TRANS/WP.29/GRE/2005/20  
18 February 2005

World Forum for Harmonization of Vehicle Regulations (WP.29)

PROPOSAL FOR DRAFT AMENDMENTS TO REGULATION No. 112  
(Headlamps emitting an asymmetrical passing beam)

Transmitted by the expert from the Working Party "Brussels 1952" (GTB)

**Table B - Class C Headlamp - Secondary high beam operated with a passing beam headlamp or a primary driving beam headlamp**

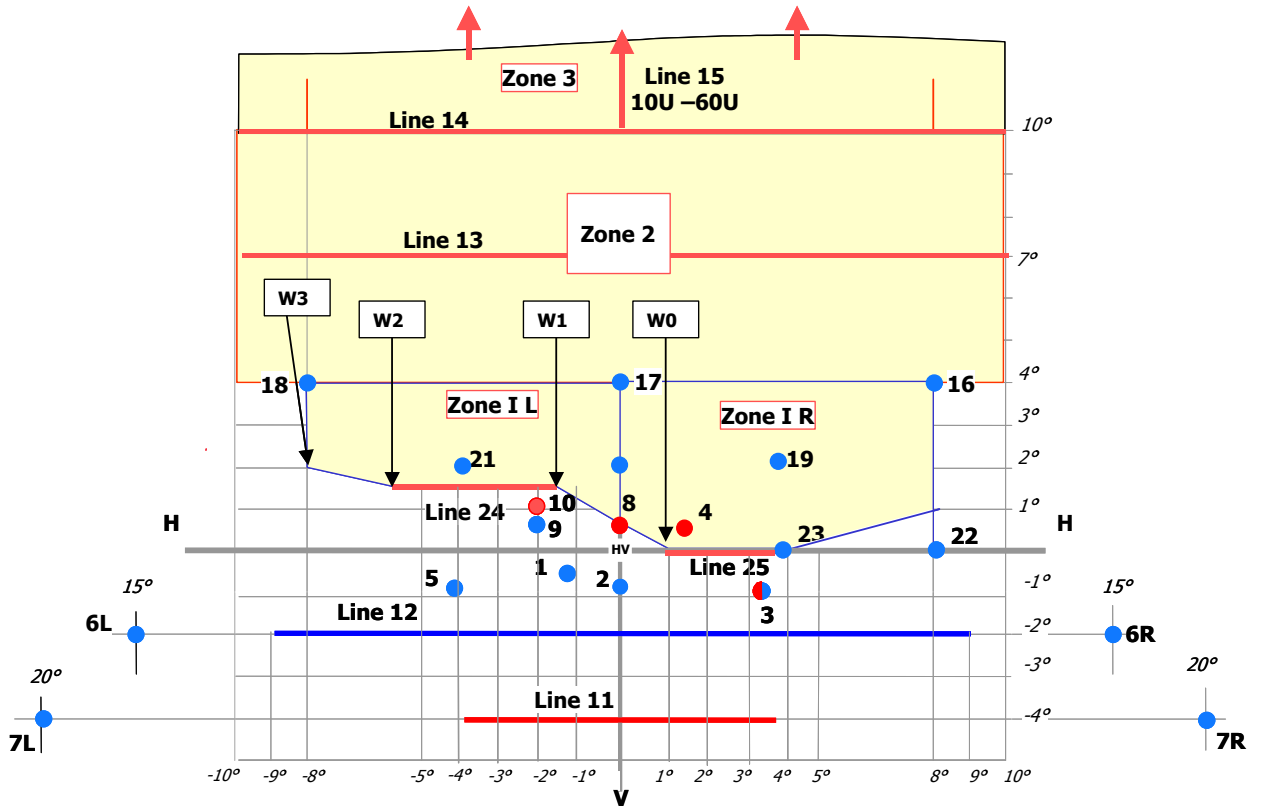
Insert, after the title, tables A and B, to read:

Refer to Figure G for details of test point positions

TEST POINT NUMBER	TEST POINT LOCATION	Required illuminance in lux	
		Min.	Max.
1	H-V ( <u>1/</u> )	<u>1/</u>	---
2	H-3R & 3L	20	---
3	H-6R & 6L	7	---
6	2U-V	2	---
7	4D-V	---	<u>2/</u>
	Peak illuminance anywhere in the beam pattern	50	180

**"Figure F: Primary driving beam**

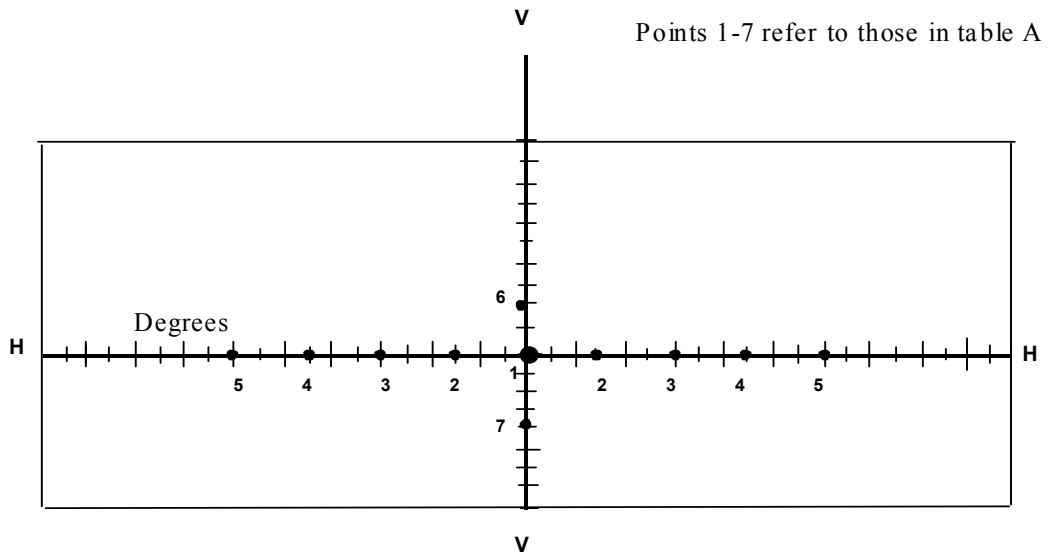
**Table A - Class C Headlamp -Primary high beam**

Refer to Figure F for details of test point positions

TEST POINT NUMBER	TEST POINT LOCATION	Required illuminance in lux	
		Min.	Max.
1	H-V <u>1/</u>	<u>1/</u>	---
2	H-3R & 3L	20	---
3	H-6R & 6L	7	---
4	H-9R & 9L	4	---
5	H-12R & 12L	1.2	---
6	2U-V	2	---
7	4D-V	---	<u>2/</u>
	Peak illuminance anywhere in the beam pattern	50	180.0

Add at the end of Annex 3 figures F and G, to read:

**Figure 1**

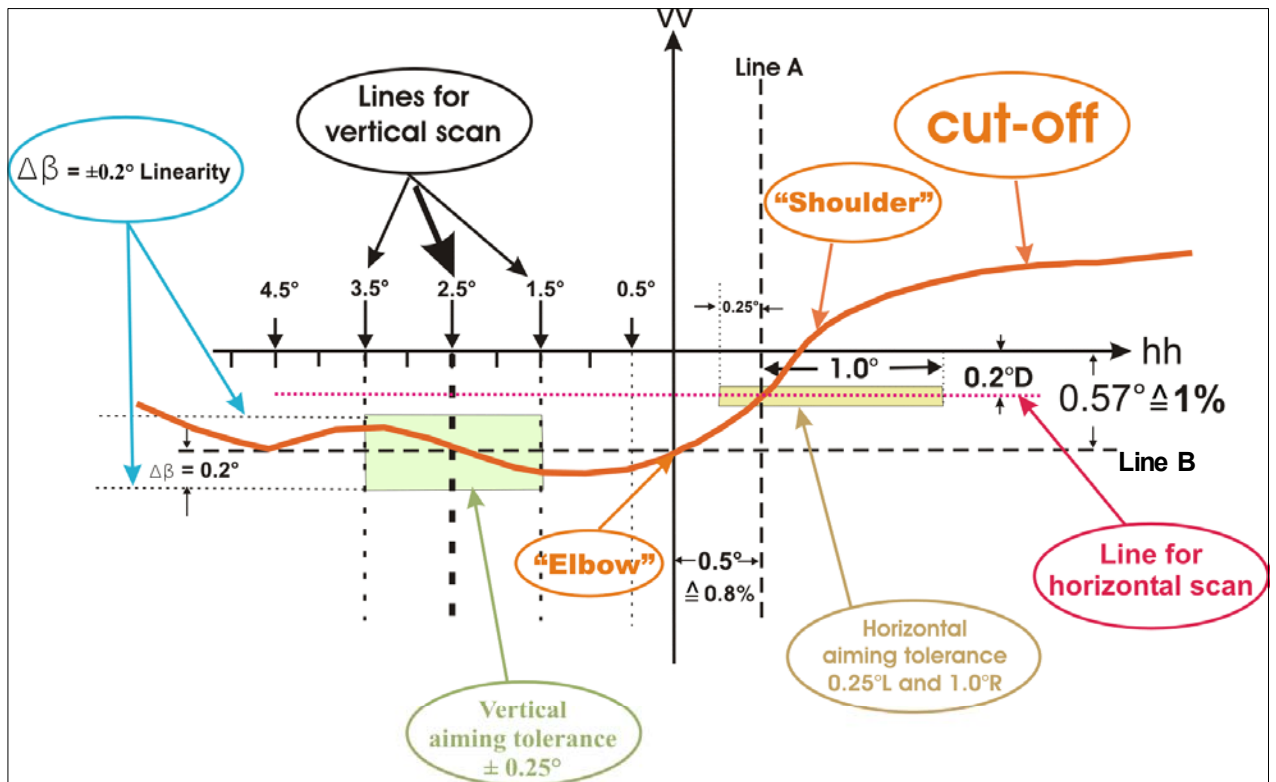
The cut-off line shall provide a straight horizontal line between 1.5° and 3.5° to the left of the v-v-line (see Figure 1)(to the right ....)

**Figure 2:** Instrumental vertical and horizontal adjustment - horizontal line scan method

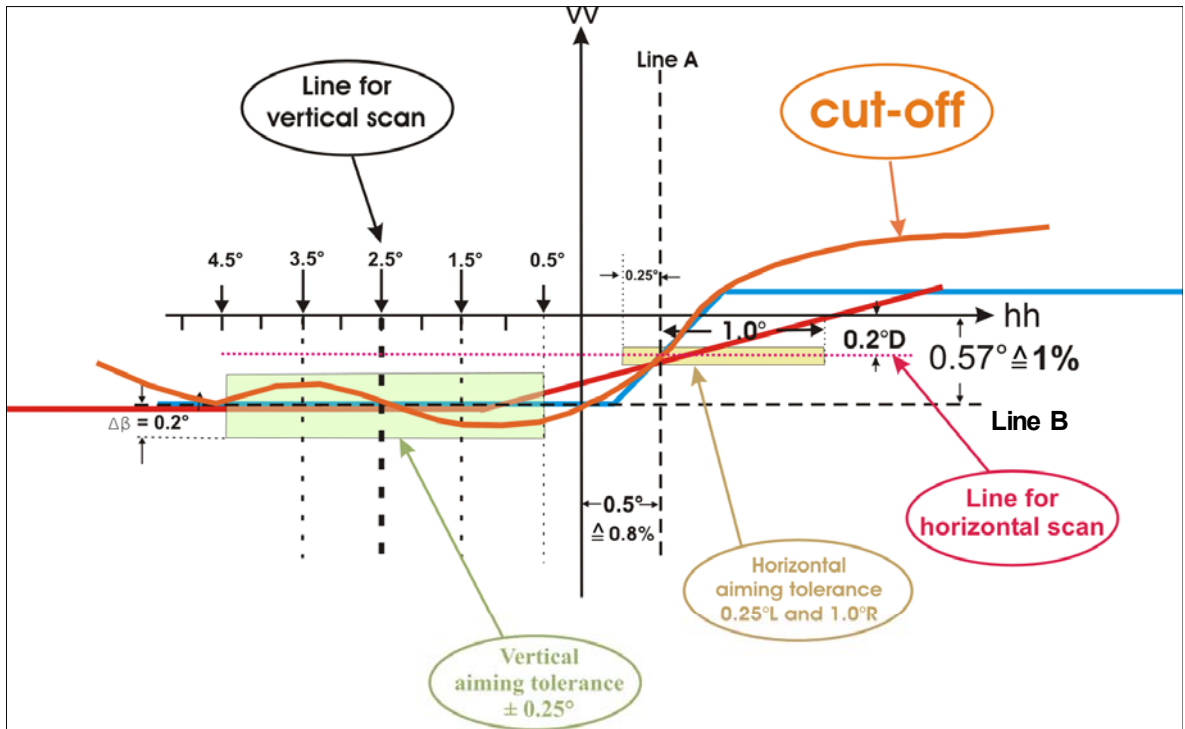
**If the "0.2D line" method (Figure 2) is used, a single horizontal line shall be scanned. The minimum gradient found on the 0.2D line shall be not less than 0.08.**

**If the "0.2D line" method (Figure 2) is used, a single horizontal line at  $0.2^\circ\text{D}$  shall be scanned from 5L to 5R after the lamp is aimed vertically. The maximum gradient determined as defined in paragraph 4.2. above, shall not be less than 0.08. The maximum gradient positions found on the 0.2D line shall be placed on the V line."**

**Figure 3:** Instrumental vertical and horizontal adjustment - three line scan method

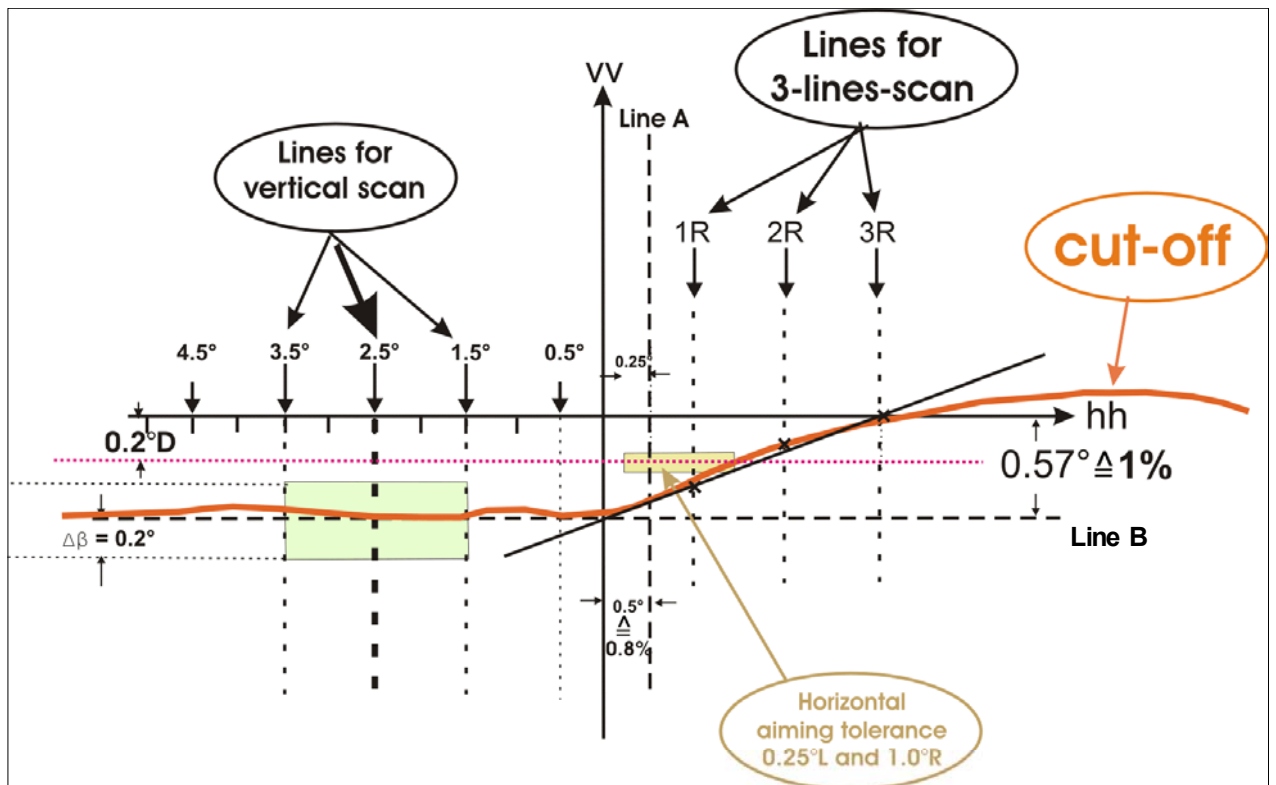
**If the "3 line" method (Figure 3) is used, 3 vertical lines shall be scanned at 1R, 2R, and 3R after the lamp is aimed vertically.**

**If the "3 line" method (Figure 3) is used, 3 vertical lines shall be scanned at  $2^\circ\text{D}$  to  $2^\circ\text{U}$  at 1R, 2R, and 3R after the lamp is aimed vertically. The maximum gradient determined as defined in paragraph 4.2. above, shall not be less than 0.08 and "A" is the vertical angular position. The maximum gradient positions found on the 3 lines shall be used to construct an angled straight line. The intersection of this line and the  $0.57\text{D}$  position found while performing vertical aim shall be placed on the V line.**
